ADDENDUM NUMBER TWO

DUPONT PUMP STATION AND BASIN IMPROVEMENTS – PHASE 2 (Contract B) W-12-026-203

CITY OF CHATTANOOGA, TENNESSEE

MANHOLE VENT
DETAIL
NTS (A)

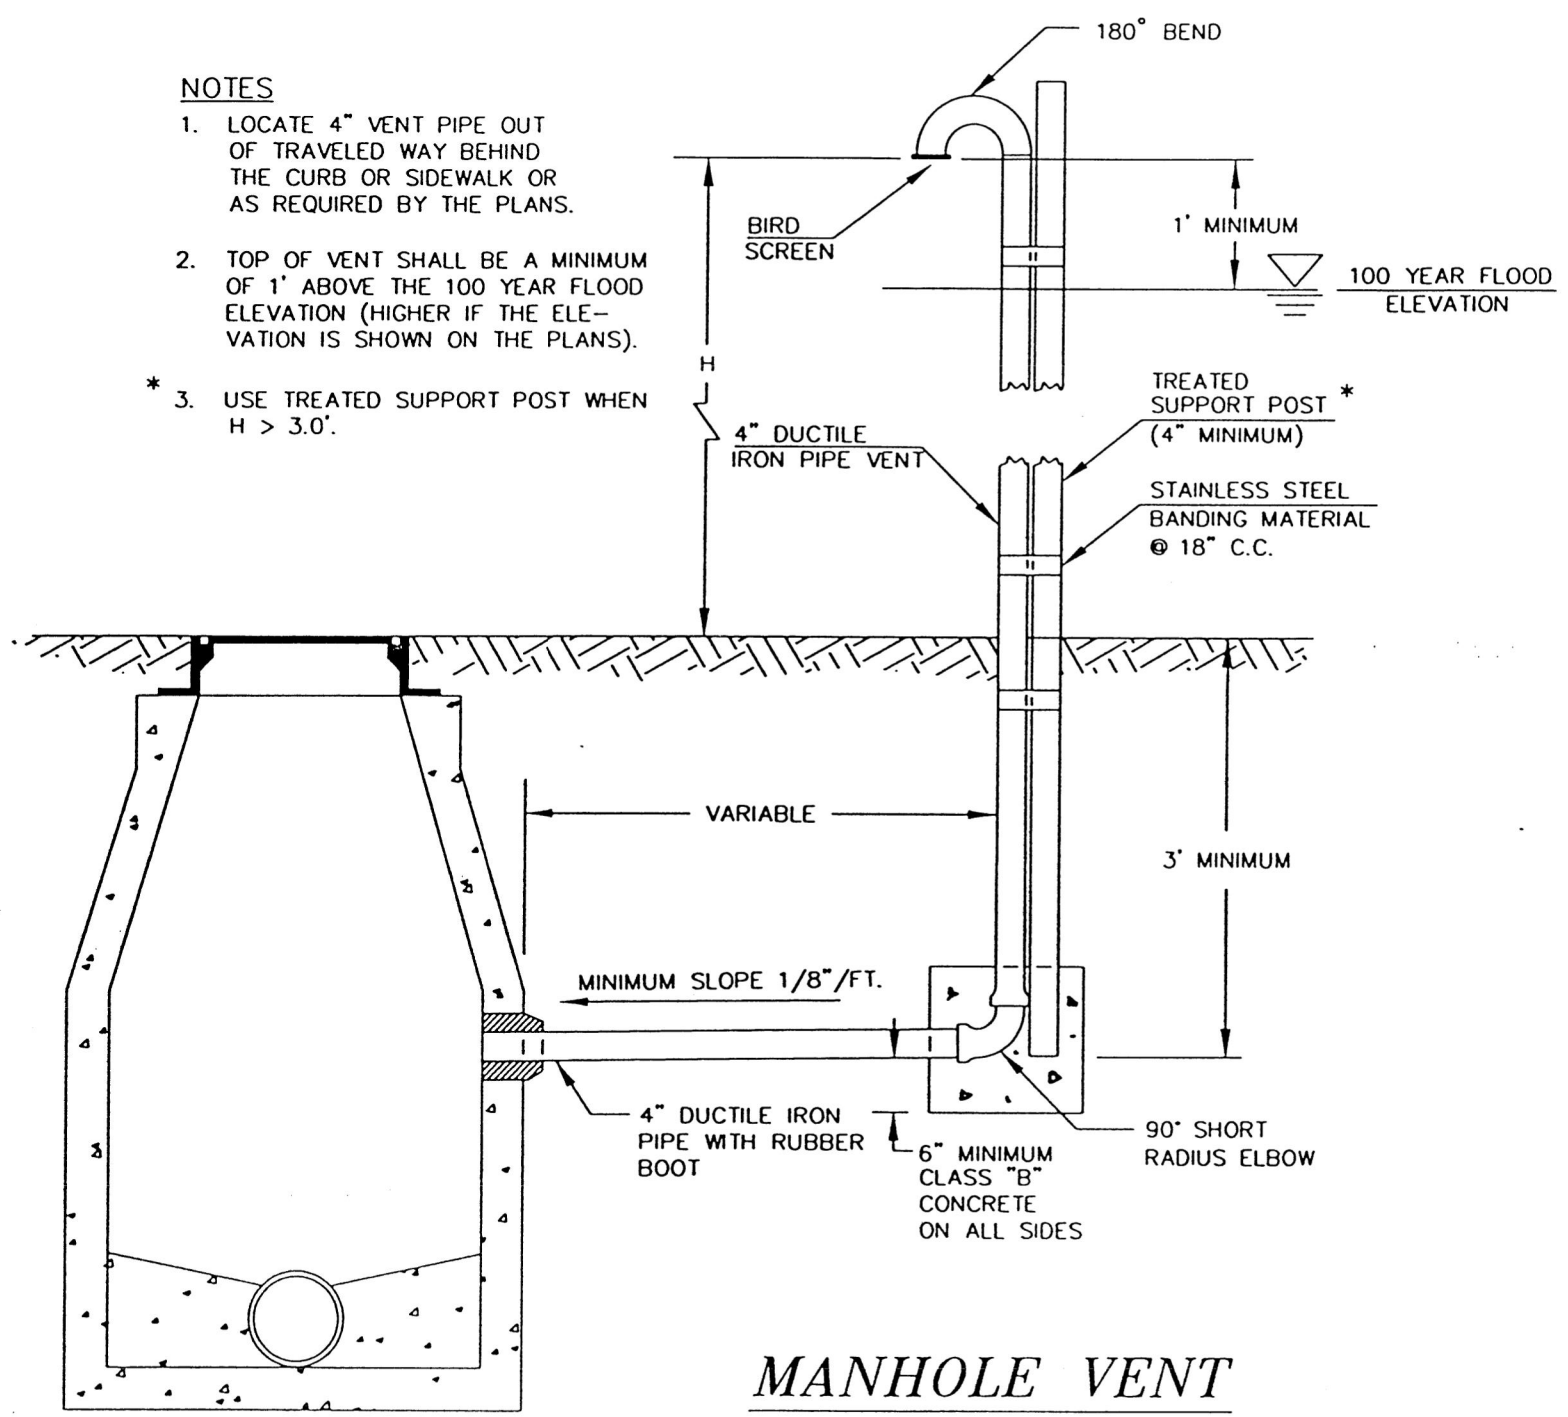
20. MH G on Sheet C-3 calls for a vent. Can you provide a detail for this work? How will it be paid?

Response: A detail has been added to the attached Sheet CD-6. The revised bid form is attached to Addendum No. 2.
